RE: Urgent Medical Device Correction- Baxter Corporation, Novum IQ Large Volume Pump

# Urgent Medical Device Correction:

# URGENT MEDICAL DEVICE CORRECTION

Figure 1: Rotate Door Open and Shut to confirm Valve movement

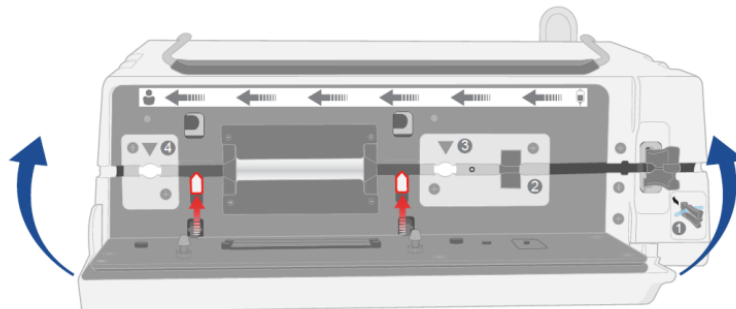
Step 1	Step 2
Confirm pumping mechanism valves (2 white valves when door is open) are not stuck and move up and down. See figure below.	Listen for any atypical sounds coming from the pump.

## If any issues are identified:

- Label the pump with a biomedical requisition and bring the pump to your manager

*Figure 1: Rotate Door Open and Shut to confirm Valve movement*

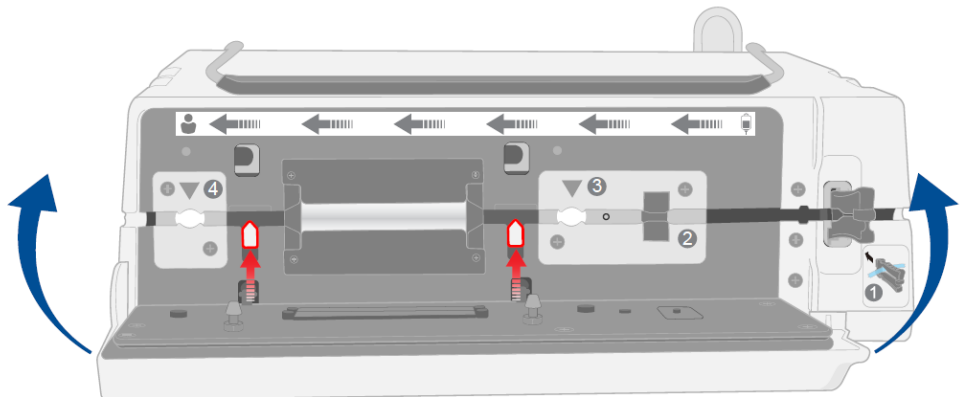
1. Operators may continue to use the Novum IQ LVP. Prior to use, confirm pumping mechanism valves (outlined in red in Figure 1) are not stuck and move up and down as the Novum IQ LVP door is rotated open and shut. If the mechanism valves are stuck or not moving up and down with the rotation of the door, immediately discontinue the use of the device.
